# Cycle Route Audits – Key Findings

## Corridor 1A: Kettering Town Centre to A43 Roundabout.

### North Route (Slide 1 of 5)

### East Route (Slide 1 of 5)

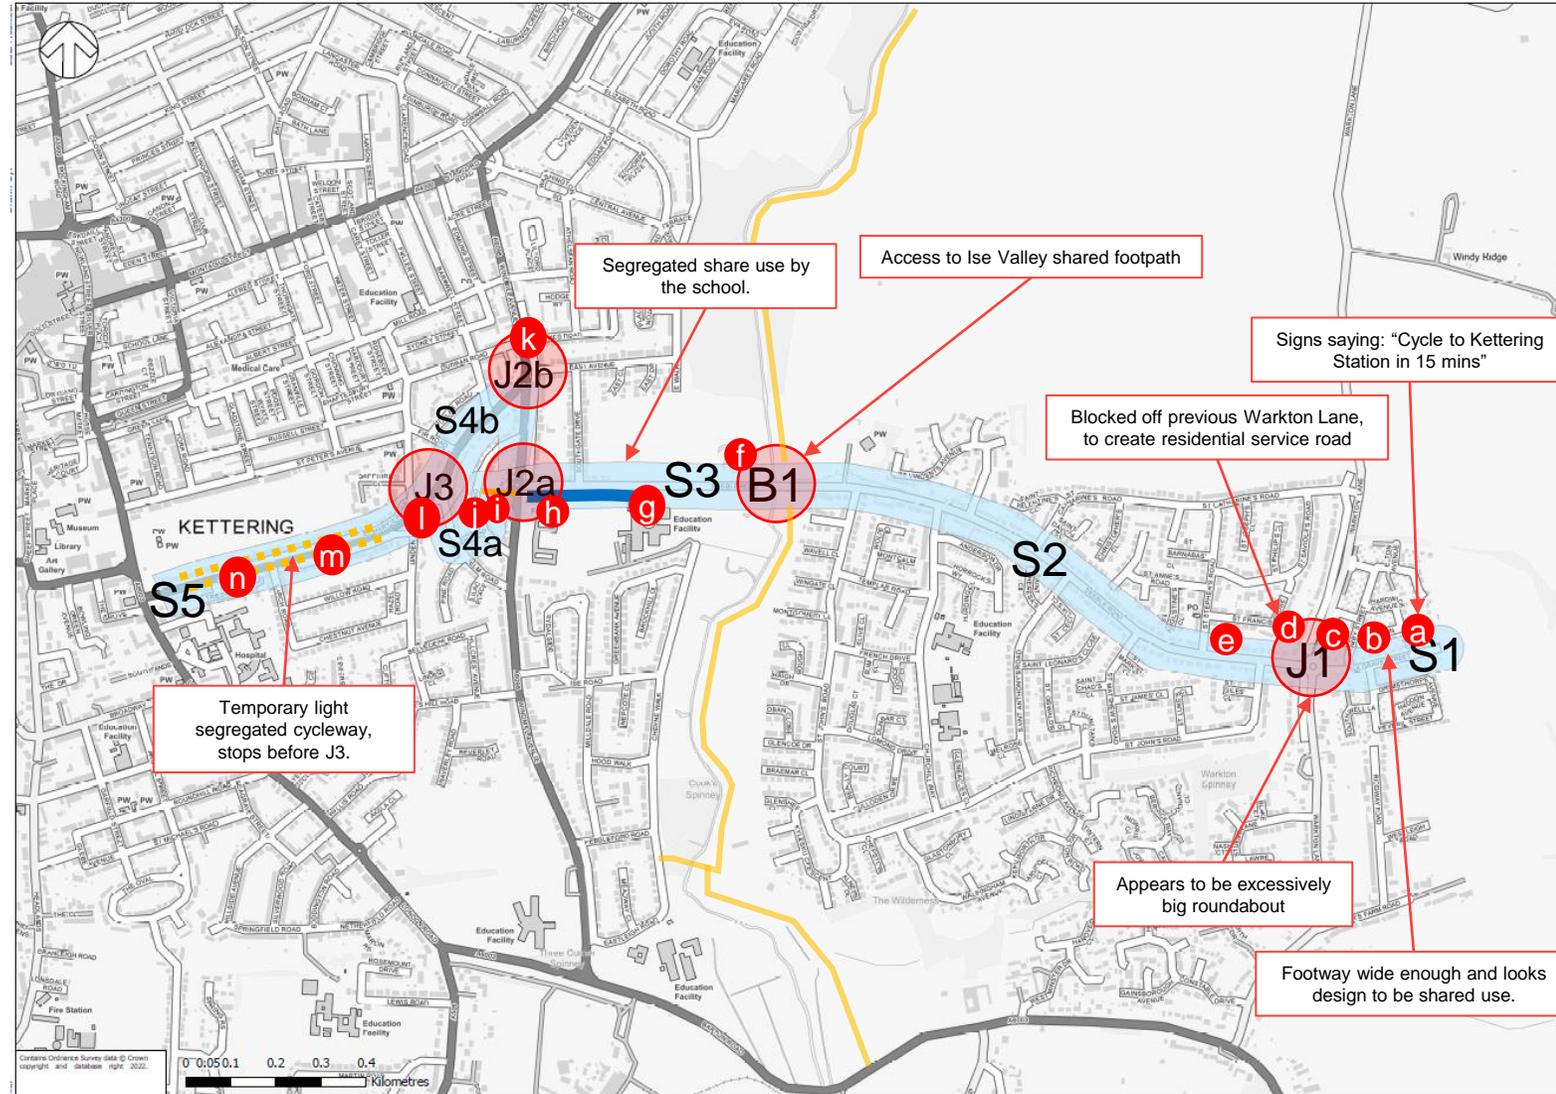
**S1** – Recently constructed Hanwood Park development with wide footways that look like they have been designed for shared use, but not clearly defined yet. Signage promoting “Cycle to Kettering Station in 15 minutes” (Photo A,B).

**J1** – Very large roundabout with 2 lane approaches on all arms, diverts pedestrian and cycle desire lines. Seems excessive.

**S2** – Residential road with driveway access and grass verges on both sides of the carriageway. Moderate gradient. Some on street parking.

**B1** – Deeble Road Bridge over the Rive Ise. Wide carriageway with hatching and wide footways on both sides. Connection with the Ise Valley shared use route.

**S3** – Wide carriageway with central hatching and grass verges on both sides until the entrance to Kettering Science Academy (Photo G). West of the Academy entrance there is a section of two-way cycle way segregated by a white line from the footway up to **J2a**. (Photo H).

**J2a** – Large 3-armed roundabout with 2 lane approach arms, un signalised pedestrian crossing facilities, particularly busy at school start and end times.

**J2b** – Oversized 3-arm roundabout with painted island, faded markings and required maintenance. (Photo K). No pedestrian or cycle crossing facilities, no dropped kerbs, perceived high vehicle speeds.

**S4a** – Quiet, low traffic residential streets, with a pedestrian cut through from **J2a** (Photos I and J).

**J3** – Wide priority junctions from Elm Rd on to St Mary's Rd forming a triangle of grass, (Photo L), vehicles carry speed in Elm Rd due to lack of deflection.

**S5** – A wide, busy road with residential service roads set back. Existing temporary light segregated cycle lanes along a section. (Photos M and N)

East Central Route (Slide 1 of 4)

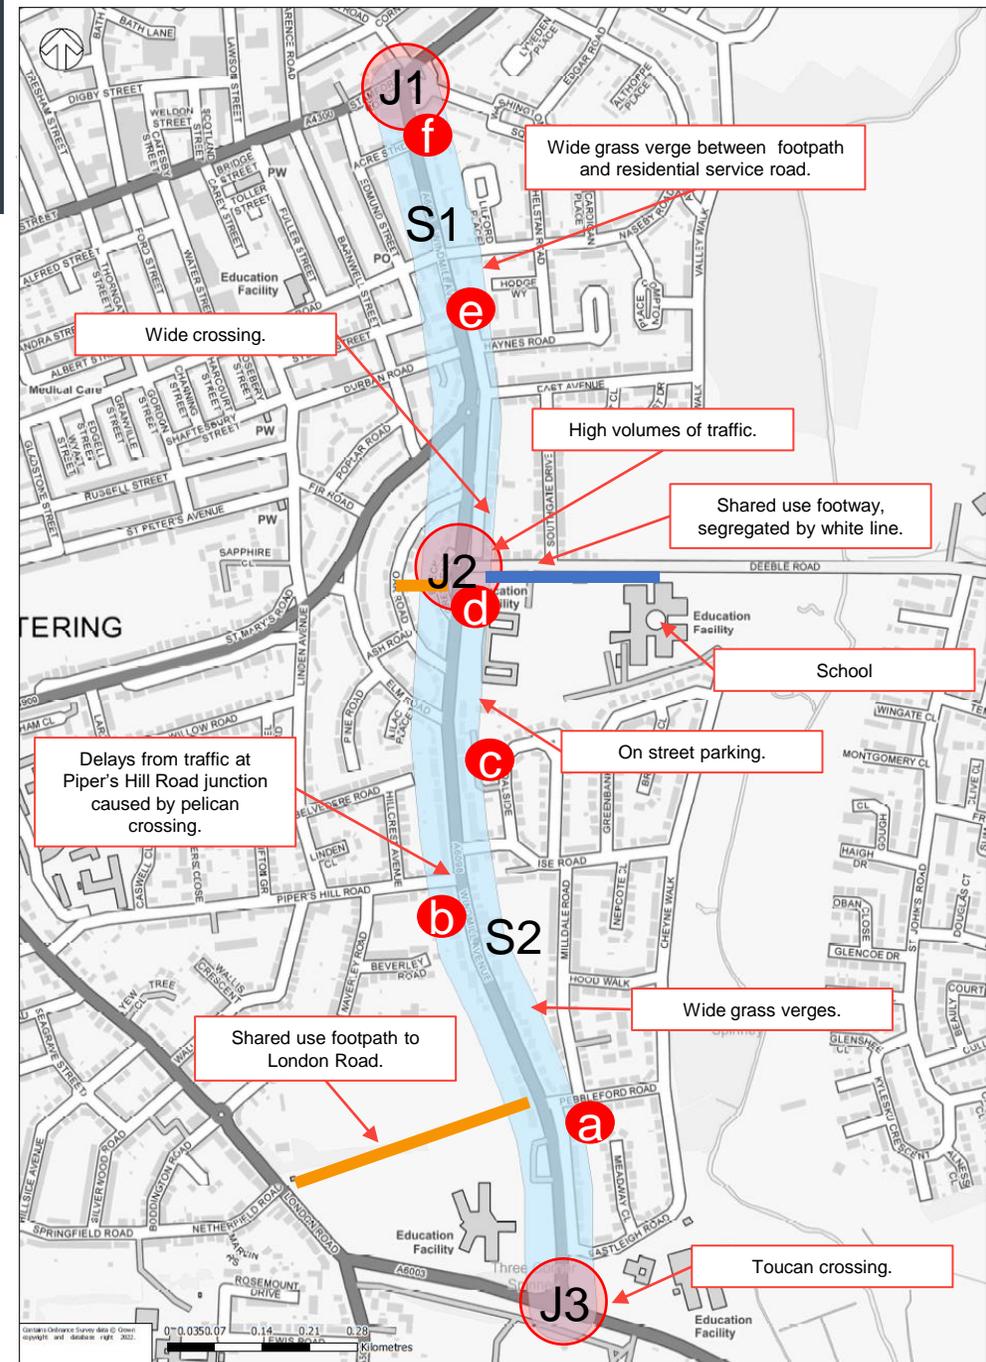
**J1** – Included in the Corridor 3, J2. Busy and constrained roundabout with wide diameter but a painted island. Lack of crossing facilities and dropped/tactile paving. Faded marking in need of improvement. Minor side roads on the Windmill Ave approach without dropped kerbs make it negative junction for pedestrians and cycles. (Photo F).

**S1** – Busy section of carriageway with lots of side roads and kerbside activity. Constrained by trees and kerb parking. The southern section of S1 has a parallel residential service road to the east of the carriageway, separated by a grass verge. (Photo E).

**J2** – Wide diameter 3-arm roundabout with 2 lane approaches. High volumes of traffic, especially during school drop off/pick up hours. Uncontrolled pedestrian crossing provision. (Photo D).

**S2** – Very constrained section with limited carriageway width, mature tree lined verges, lots of kerbside activity and on-street parking (Photo C). Delays on Piper's Hill Road joining this section of the route caused by a pelican crossing north of the junction. Lots of footfall and high volumes of traffic around due to school drop off/pick up hours. Has a wide residential entrance just south of **J2** which feels unsafe to cross. On street parking along section approaching and busy with movements associated with Tresham College to the south of the section.

**J3** – Undergoing construction work during site audits so had temporary lights and restricted vehicle movements. Would appear to be a busy signalised T-junction with separate signalised left movements. Pedestrian movements complicated by splitter islands.

Wicksteed Park Route (Slide 1 of 4)

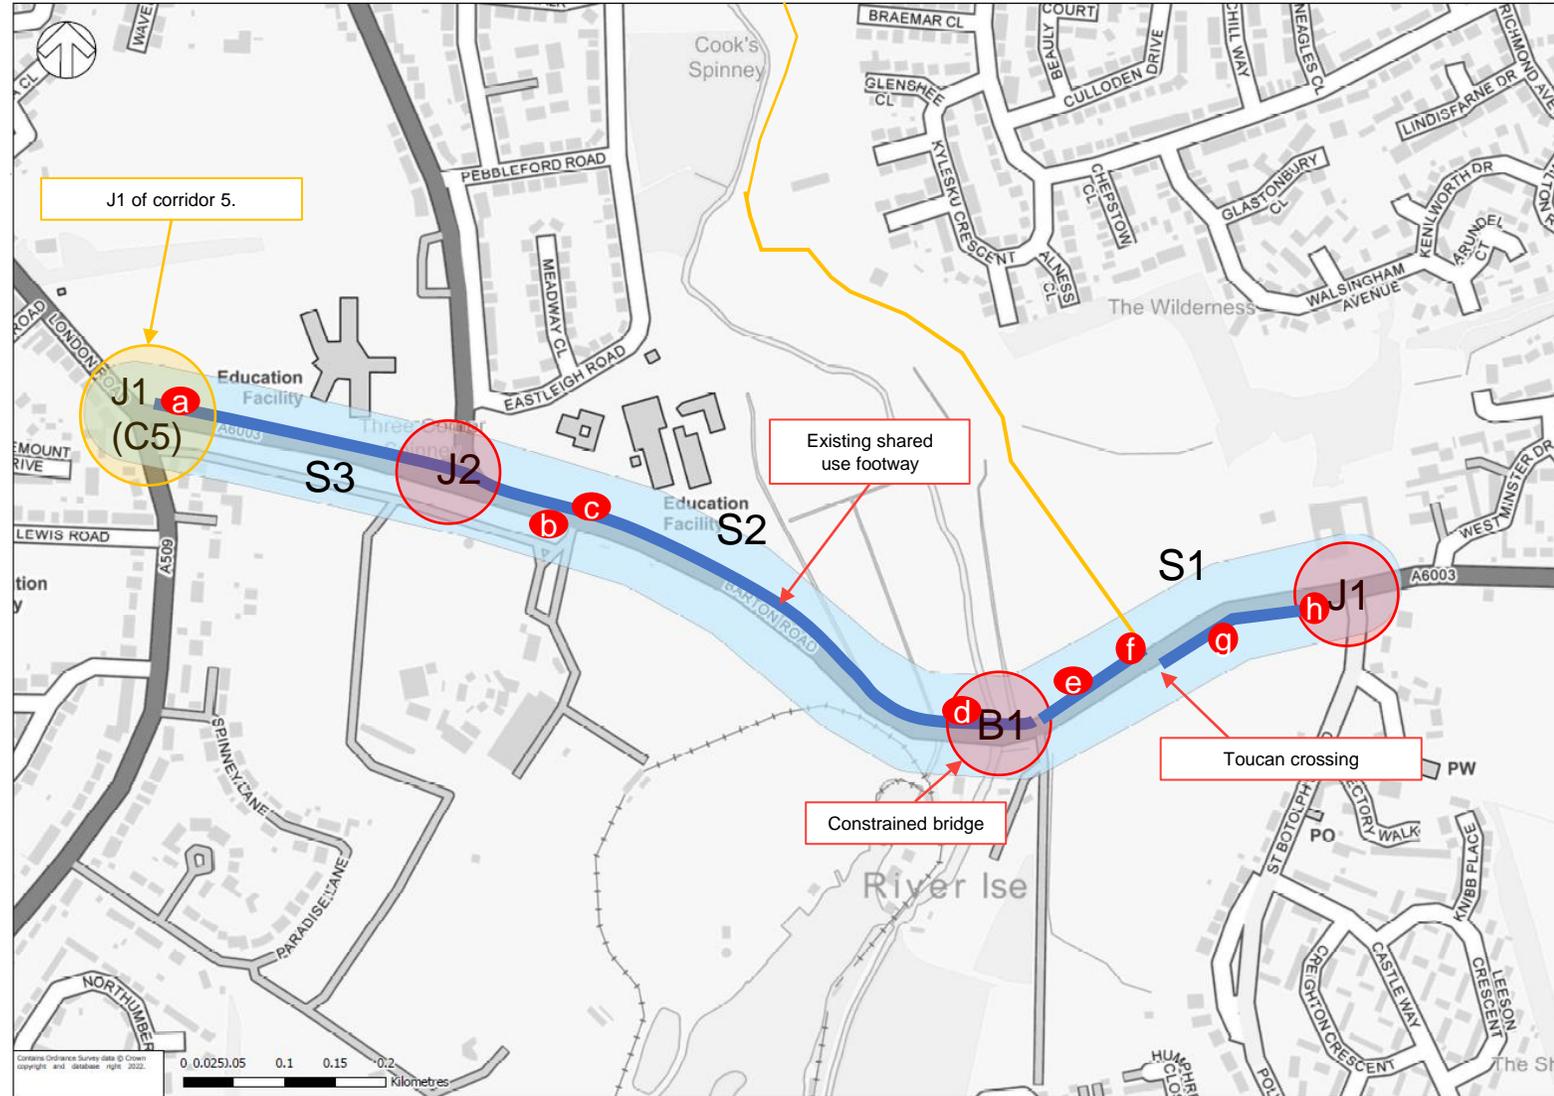
**J1** – Existing signalised T-junction with Toucan crossings, recently updated. Shared use footway on the south side.

**S1** – Existing shared use footway on the south side of carriageway before a Toucan crossing connecting to the Ise Valley shared footpath route. (Photo G and F).

The shared footway continues on the north side of Barton Rd after the Toucan crossing (Photo E) to the Bridge (B1) over the River Ise.

**B1** – The bridge has been widened on both sides but the original brick/stone work remains and reduces the footway width. (Photo D).

**S2** – Existing shared use footway on the north side of Barton Road (Photo C), passing the entrance to Wicksteed Park (Photo B).

**J2** – Signalised T-junction currently undergoing construction work.

**S3** – Existing shared use footway continues on the north side of Barton Road to the junction with London Rd **included in Route 5**.

South West Route (Slide 1 of 5)

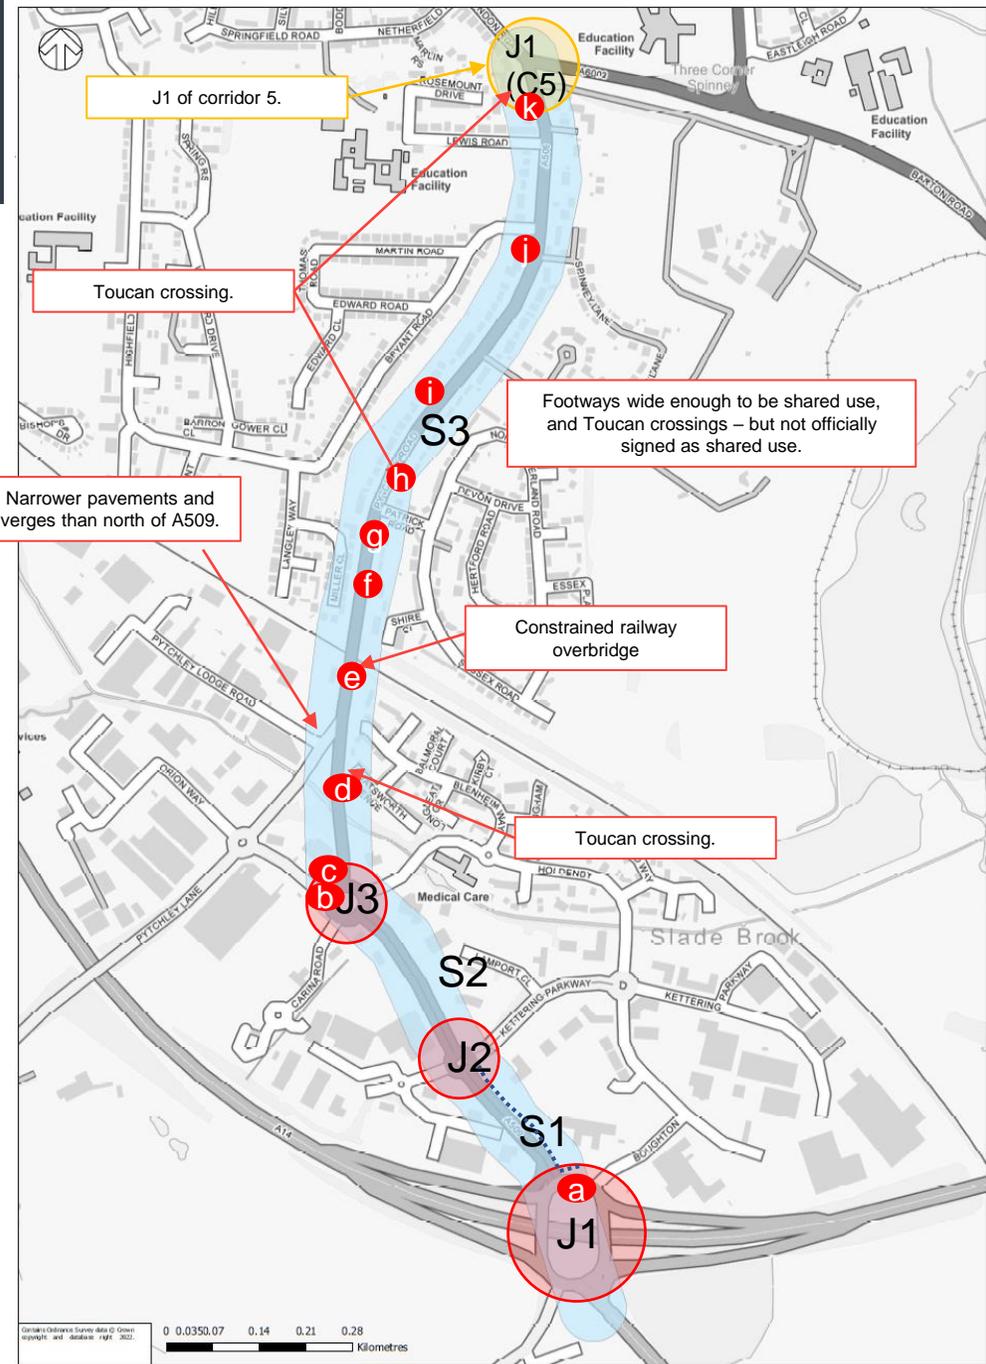
- J1** – Busy grade separated roundabout junction of A14 (Junction 9) and A509. Previously had no pedestrian provision, but construction work was being undertaken while undertaking the audit to create a shared footway on the north side of the junction connecting to Kettering Venture Park. (Photo A).

- S1** – Like S1, busy dual carriage way with only partial footways, but construction work was being undertaken while undertaking the audit to create a shared footway on the north east side of the carriageway.

- J2** – Large 4-arm roundabout with 2-lane approach arms. Footway provision on some of the arms, but informal pedestrian crossing on Kettering Parkway only.

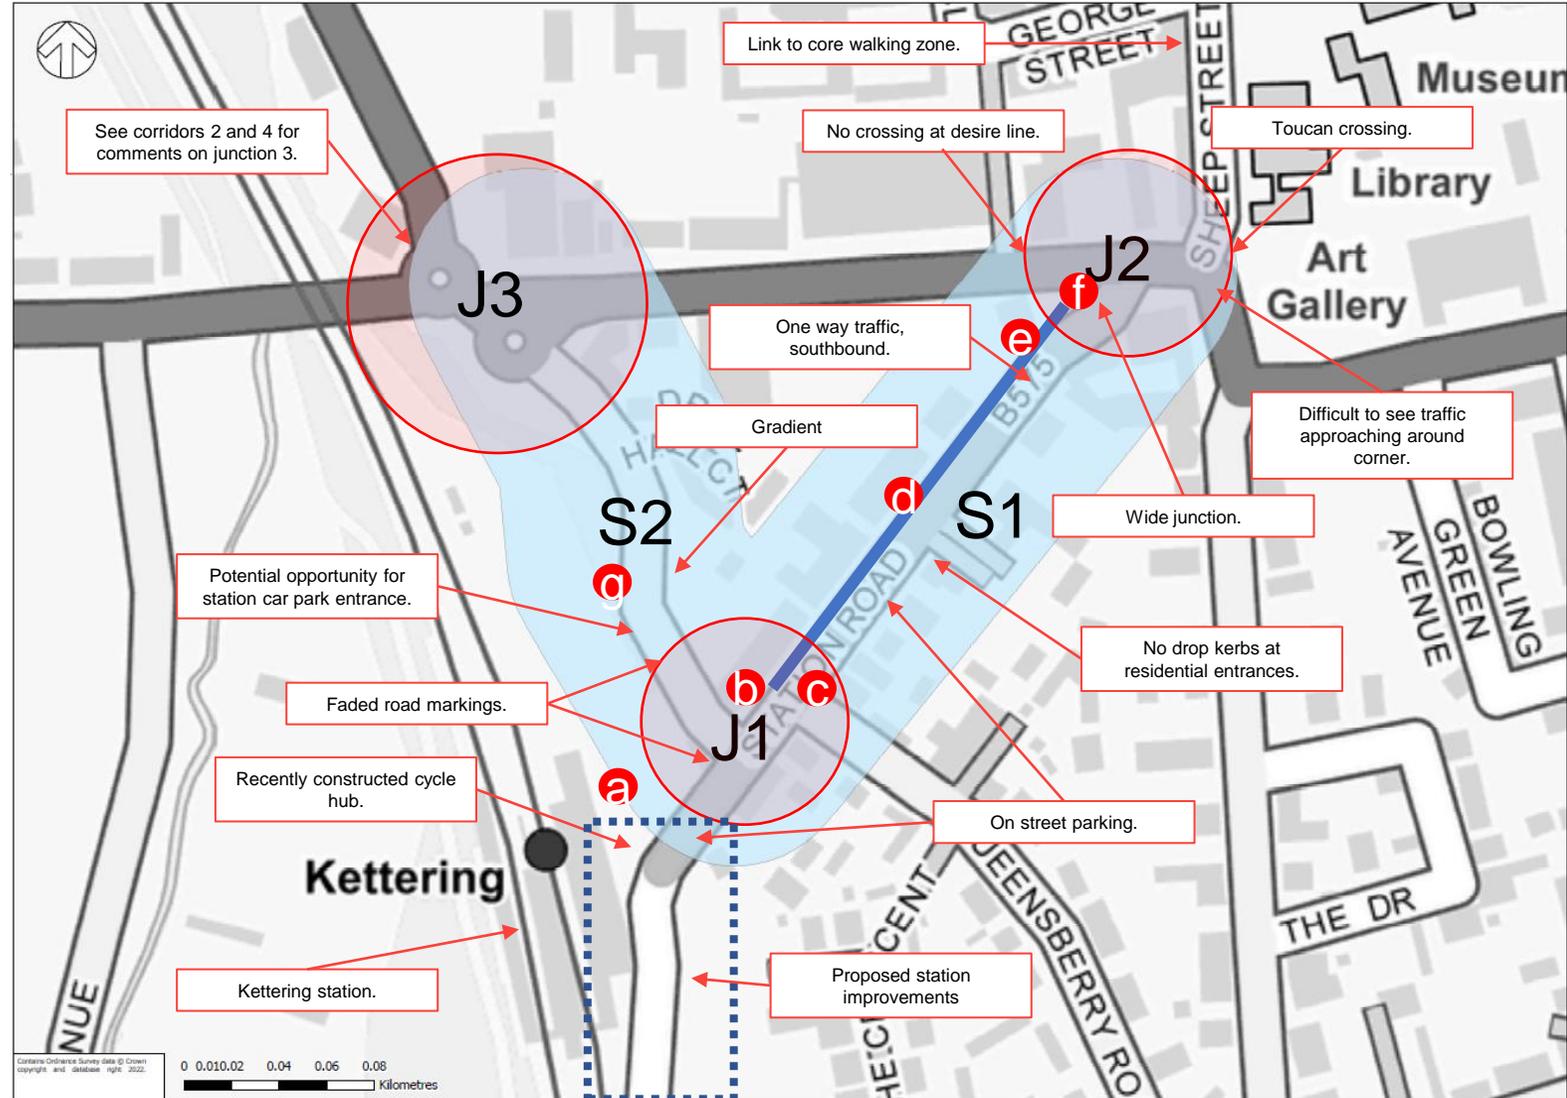
**Kettering Station Access** – Proposals for improved station approach with improved public realm and taxi drop off provision. Recent construction of a new ‘Cycle Hub’ (photo A).

**J1** – No formal crossing provision at Northfield Ave / Station Rd junction

**S1** – Low traffic volumes along section. Wide footway with existing shared use footway on the north side of the carriageway (photo D). On street parking and some missing dropped kerbs on the south of the carriageway.
